## SERVICE BULLETIN

**DATE:** 1-19-2015 **BULLETIN NO:** 15-003

**TITLE:** 6700SJ2 BUGGY BIAS ACTUATOR SYSTEM

**PRODUCT SERIES / MODEL:** 6700SJ2 MACHINES WITH SELECTABLE LINE RAIL OPTION AND LASER LINER SYSTEM INSTALLED

**FIGURE 1.0 - BIAS ACTUATOR BRACKET DRAWING**

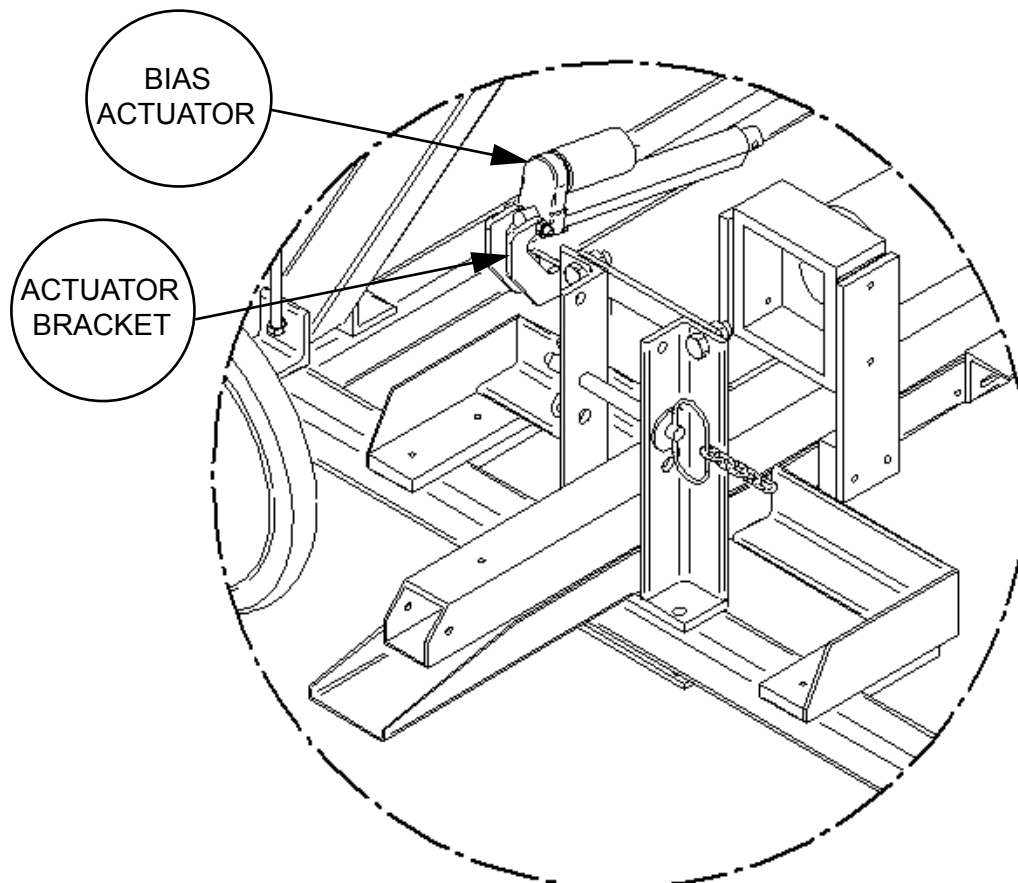
**SUMMARY:** The bias actuator mounting brackets can restrict the range of motion of the actuator in some instances. In some cases the weight of the buggy cross slide is transferred to the actuator which could cause it to fail. Redesigned bias actuator brackets are available to alleviate this issue.

**ACTION:** Replace the left bias actuator bracket #5016399 with #5049670.  
Replace the right bias actuator bracket #5016398 with #5049705.

- Ensure power to the light buggy is turned off.
- Remove the left bias actuator from the left actuator mounting bracket.
- Remove the existing left actuator mounting bracket from the light buggy frame.
- Mount the new left actuator mounting bracket, 5049670, to the light buggy frame using the existing hardware.
- Mount the left bias actuator to the new left bias actuator mounting bracket.
- Remove the right bias actuator from the right bias actuator mounting bracket.
- Mount the new right bias actuator mounting bracket, 5049705, to the light buggy frame using the existing hardware.
- Mount the right bias actuator to the new right bias actuator mounting bracket
- Apply power to the light buggy.
- Both actuators will move to their extended length.
- Installation complete.
